## Urgent Field Safety Notice

### SynchroMed® II Implantable Drug Infusion Pump Design Change Models 8637-20 and 8637-40 Device Retrieval

Medtronic reference: FA794

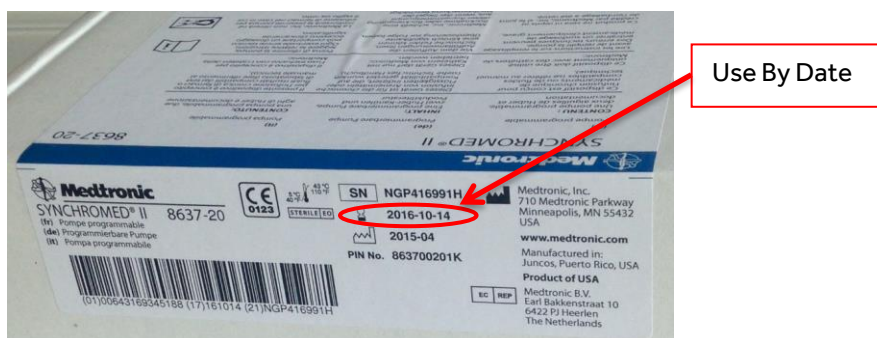
1. Review your inventory, segregate any affected product. In Europe, Middle East, Africa, Latin America and India any pump with a Use By Date **on or before** 2018-12-31 was manufactured **prior to** design change. An image of the Shelf Box Side Label of the SynchroMed II is shown below.
